Addendum – Specialist input: Healthy Waters

Subject: FTA111 – Milldale Stages 4C and 10 - 13 Fast Track – Auckland Council
Application Reference: BUN60446761

Date: 01 September 2025

Figure 1 – Public reserve activation, reproduced from Auckland Council Community Facilities memo dated 16/05/2025

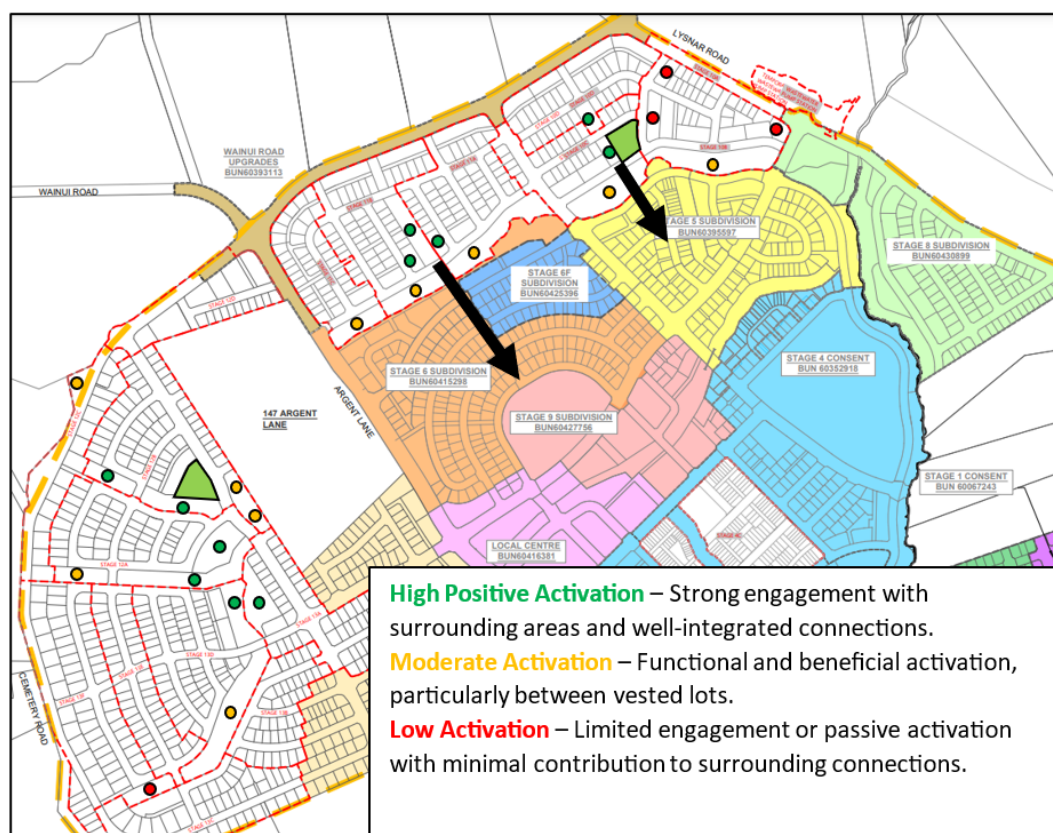
Excluding Lots 6001, 6002 and 6022, which will not be accepted as public land, the remaining public reserves have been identified by Auckland Council Community Facilities as having (refer Figure 1):

- High Positive Activation: Strong engagement with surrounding areas and well-integrated connections; or
- Moderate Activation: Functional and beneficial activation, particularly between vested lots.

Lots identified as having Moderate Activation are generally surrounded by public roads and footpaths and are disconnected from private land. In principle, these can be considered for public ownership. Lots identified as having high positive activation are achieving both stormwater and public benefit functionality and can also be considered for public ownership. Matters such as the final form, treatment, and long-term maintenance implications of the land still require further assessment which will need to be addressed at Engineering Plan Approval.

HWFR is under no obligation to accept this land where the minimum requirements set by the relevant Council standards, guidelines and codes of practice have not been met to the satisfaction of HWFR.
